Historic District Commission Meeting

7:00 PM - Tuesday, February 8, 2022

HDC Work Permit Staff Review

Property address: 506 N River Street

Proposed North (Yard) Elevation

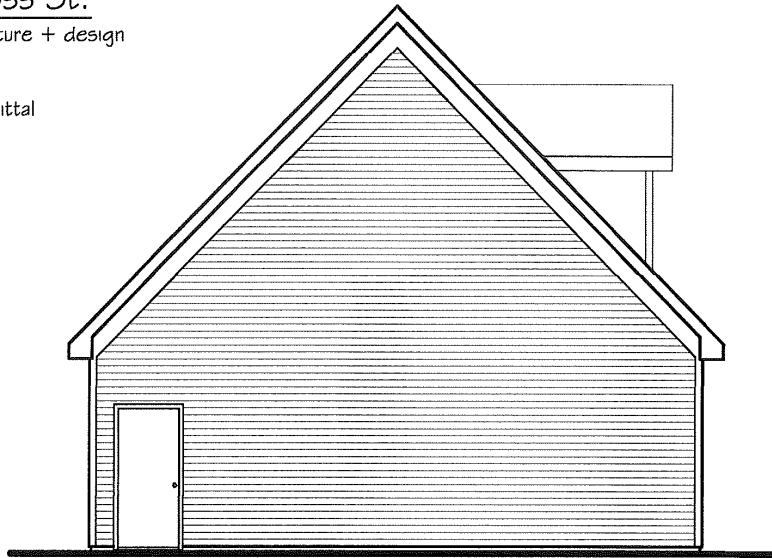
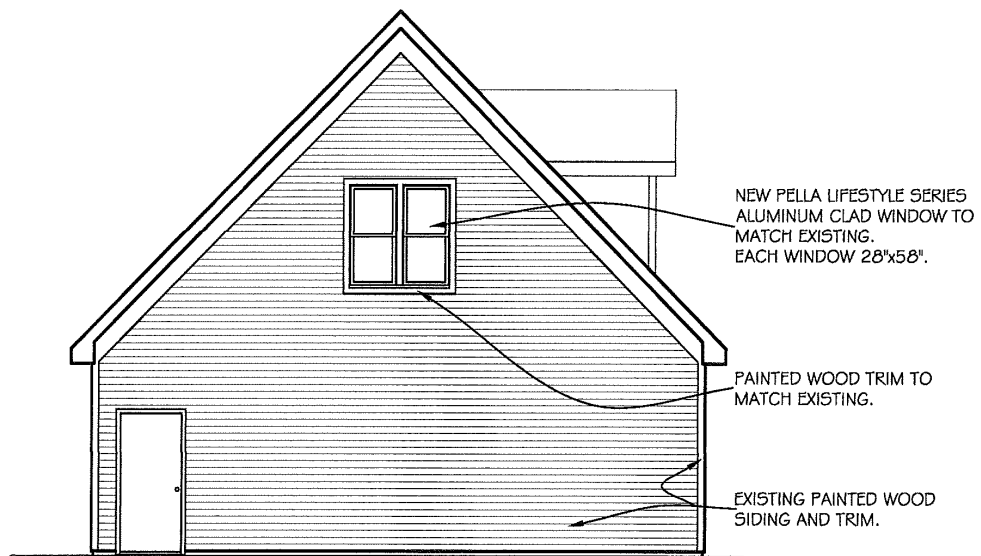
1. The applicant proposes 4 new double hung windows total. Two are centered on the north side while on the south side they are separated due to the location of an interior stairwell. The materials and type of window are appropriate for the period the garage was built and does not remove or alter historic characteristics of significance.

Move to approve and issue a certificate of appropriateness for the work at 310 E Cross, as submitted in the application dated January 25, 2022 to add four new Pella aluminum-clad double hung windows as specified.
